Z-71
(2015)

MASTER REZONING
SITE PLAN
SHEET TITLE
SCALE: 1" = 60'
DATE: JUNE 3, 2015
PROJECT: 15143.00

PETITION NO: Z-71
HEARING DATE (PC): 08-04-15
HEARING DATE (BOC): 08-18-15
PRESENT ZONING: O&I, R-20, NS

ZONING COMMENTS:

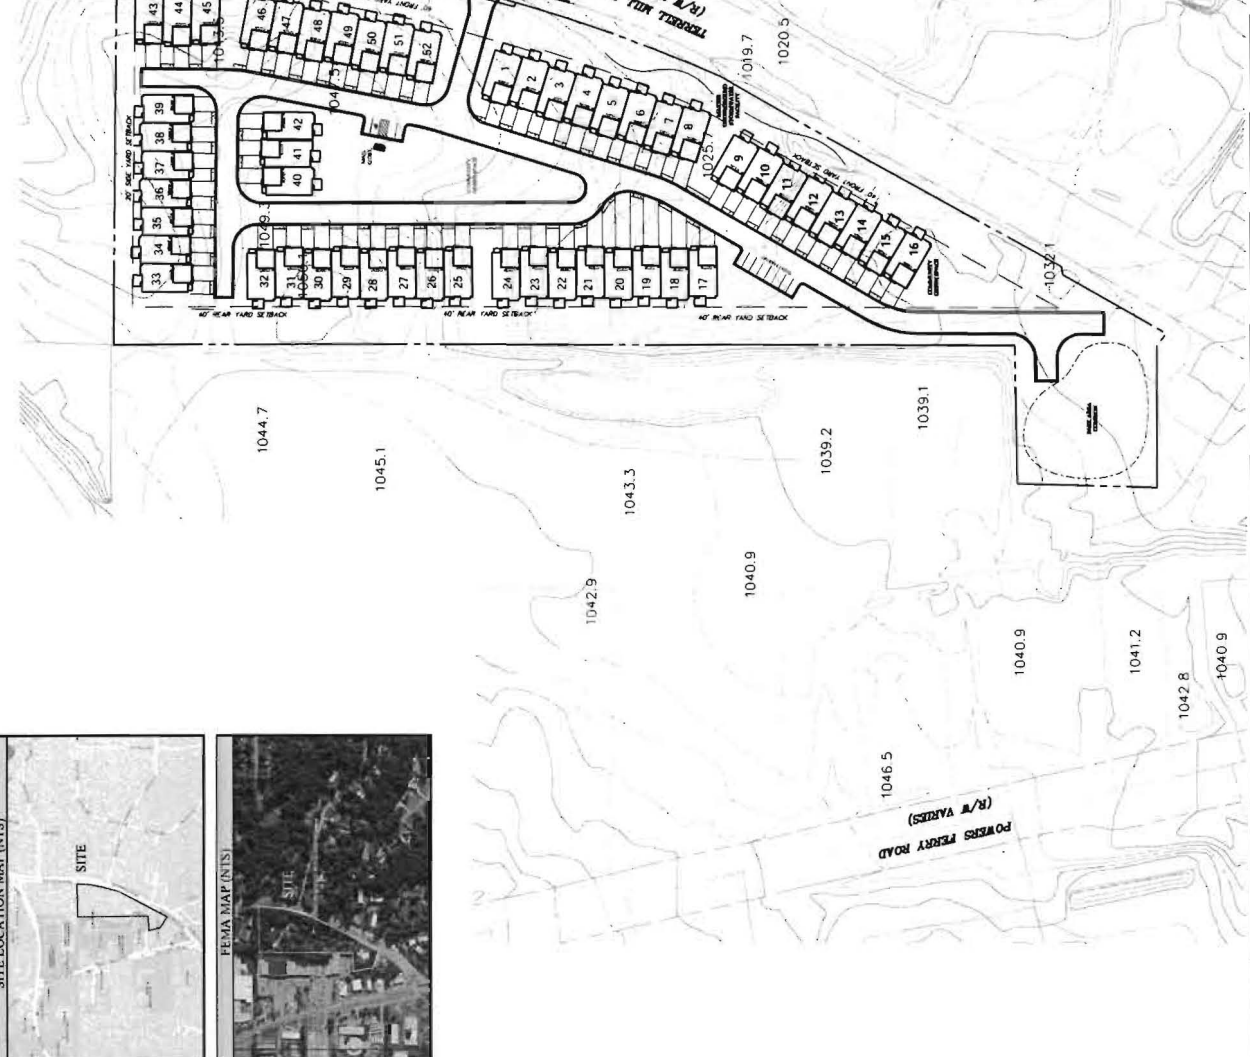
1. Waiving the required 25-foot landscape buffer abutting residential property to the north;
2. Waiving the front setback from the required 75 feet on an arterial road to 40 feet and allowing Unit 8 to be over the setback as shown on the proposed plan received June 4, 2015; and
3. Waiving the side setback from the required 35 feet to 20 feet.

- Provide comprehensive hydrology/stormwater controls to include development of out parcels.
- Submit all proposed site improvements to Plan Review.
- Any **spring activity** uncovered must be addressed by a qualified geotechnical engineer (PE).
- Structural fill _____ must be placed under the direction of a qualified registered Georgia geotechnical engineer (PE).
- Existing facility.
- Project must comply with the Water Quality requirements of the CWA-NPDES-NPS Permit and County Water Quality Ordinance.
- Water Quality/Quantity contributions of the existing lake/pond on site must be continued as baseline conditions into proposed project.
- Calculate and provide % impervious of project site.
- Revisit design; reduce pavement area to reduce runoff and pollution.

INSUFFICIENT INFORMATION

- No Stormwater controls shown _____
- Copy of survey is not current – Additional comments may be forthcoming when current site conditions are exposed.
- No site improvements showing on exhibit.

2. Although the proposed RM-8 zoning would reduce the maximum impervious coverage allowed on the site from the underlying zoning it will still result in an increase in runoff volume over the existing conditions. There are significant existing downstream stormwater management issues due to limited existing system capacity. To mitigate these existing conditions the stormwater management facility(ies) must be designed such that each design storm discharge be controlled not to exceed the allowable discharge of the next lower, more frequent storm event (ie. 5-year storm event released at 2-year rate; 10-year event at 5-year rate; etc. to 100-year event at 50-year rate). This will likely require additional area reserved for detention than the current plan allocates.

3. The development must provide adequate conveyance for runoff from the existing adjacent strip shopping center to the west through the site.

Based on the above analysis, Staff recommends DELETING to RA-6 subject to the following conditions:

- Site plan received June 4, 2015, with the District Commissioner approving minor modifications;
- Maximum of 52 units;
- Fire Department comments and recommendations;
- Water and Sewer Division comments and recommendations;
- Stormwater Management Division comments and recommendations; and
- Department of Transportation comments and recommendations.
